**7001 Grampian Drive, Deebing Heights
MEDQ Delegate Further Information Request (FIR) – 17522/2021/PDA**

The following letter has been prepared in response to the further information request from Ipswich City Council (17522/2021/PDA) dated 26/05/2022.

c5211-220701-let-further issues response

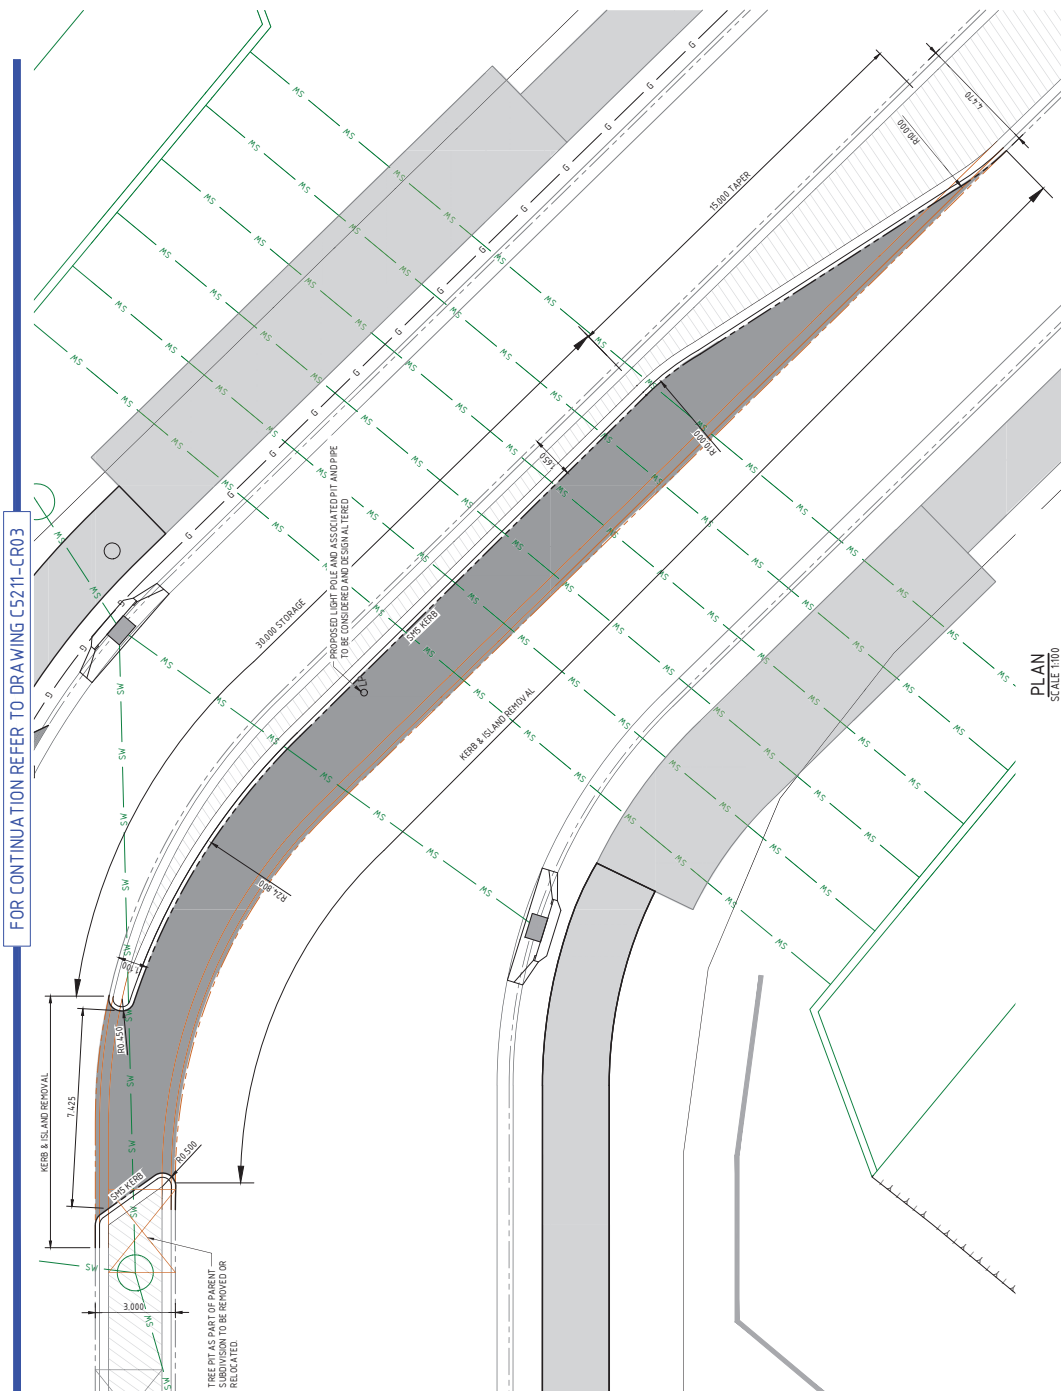
- (a) The dimensions for the lanes, medians, raised islands and footpaths for the proposed amended road design must be clearly identified on the plan/s.*

- (a) Please refer to the attached sketch C5211-CR02-REVC and C5211-CR04-REVC indicating the dimension of proposed lanes, medians, raised islands and footpaths.

VEHICLE SWEEP PATHS - SHEET 1
OF 3

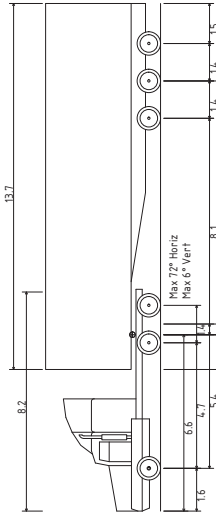
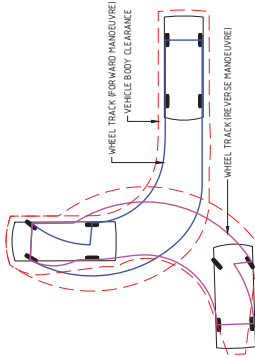
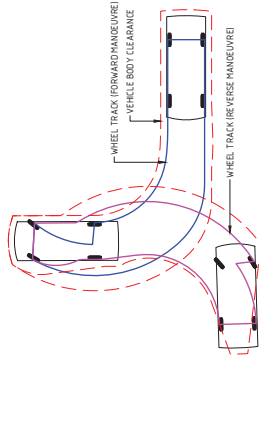
- (b) The widening of the right turn lane has reduced the through lane which will impact on traffic movements especially at the bend for refuse vehicles/buses/HRV and AV. It should be noted that AV has been approved for the Shopping Centre (Development Approval 24/2013/PDA) over the close by commercial site. As such, provide turning templates of largest anticipated vehicles along Spring Drive when the right turn lane is completely occupied.*

- (b) Please refer to the attached sketch C5211-CR08-REVA indicating the manoeuvre of an AV whilst the right-hand turn lane is completely occupied. In order to accommodate the movement, the cycle lane has been adjusted to the south. Ensuring that adequate land width results for both the central aisle and the cycle lane the central chevron extent has been reduced. Also attached is original approval 6921/2018/OW showing the previously approved lane width and line marking location and set out. These alterations to the traffic lane to accommodate the movement of the AV would be required irrespective and independent of the proposed new right turn lane within the central median for childcare centre access. That is, the proposed right turn lane does not alter the AV path requirement.

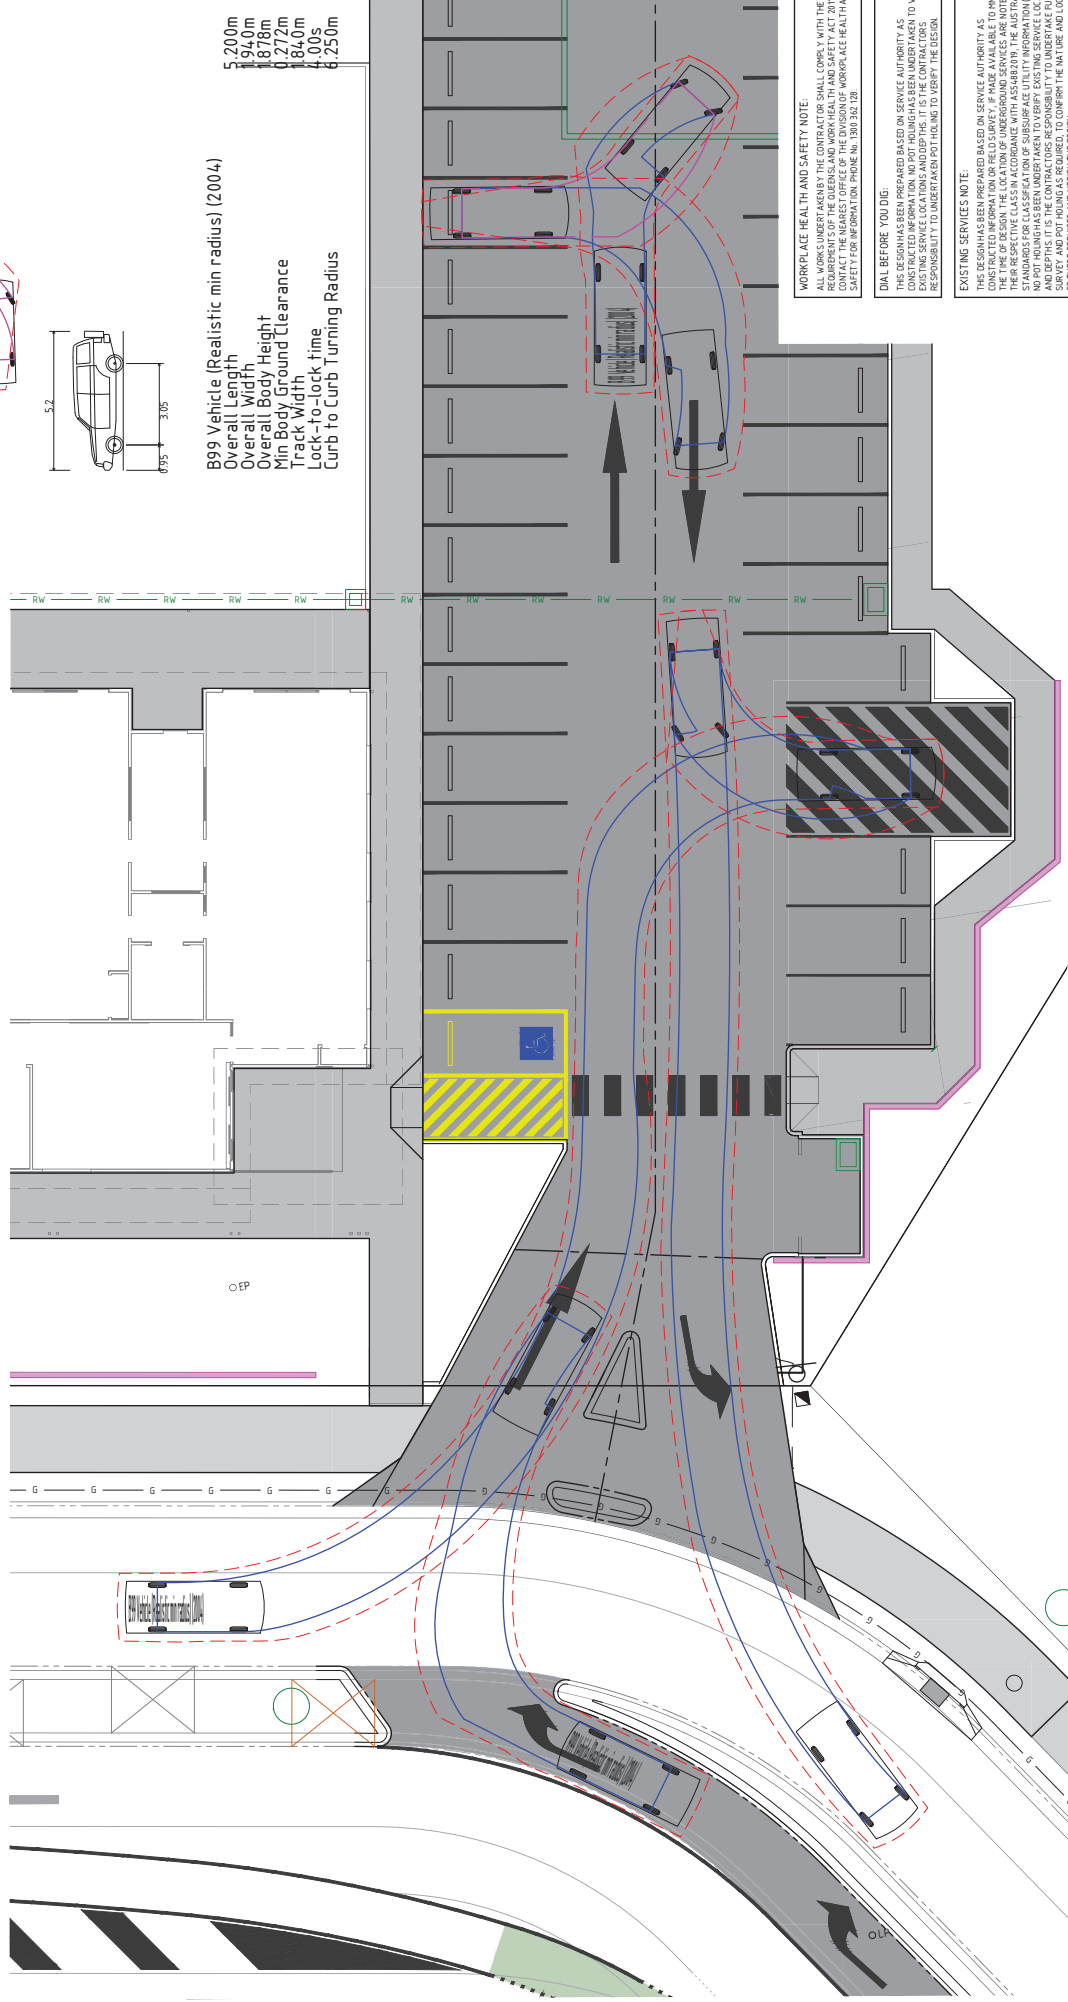
- (c) The submitted turning templates are confusing as they are overlapping, and it is not clear if it is for B99 or refuse vehicle. As such, turning templates (specifically for refuse vehicles) that are not overlapping must be submitted and the size of the vehicles must be clearly illustrated on the plans.*

- (d) The line marking, refuse islands and kerb lines must be clearly illustrated with respect to turning templates to ensure the paths are contained within the lanes and comply with AS 2890 series. The turning templates must be continuous from the Grampian Drive intersection to ensure they are contained within the lane and not encroaching onto any external structures and cycle lanes.*

- (c) Within attached sketch C5211-CR09-REVA and C5211-CR10-REVA refuse vehicle and B99 movements are shown.
- (d) Within attached sketch C5211-CR09-REVA and C5211-CR10-REVA refuse vehicle and B99 movements are shown.
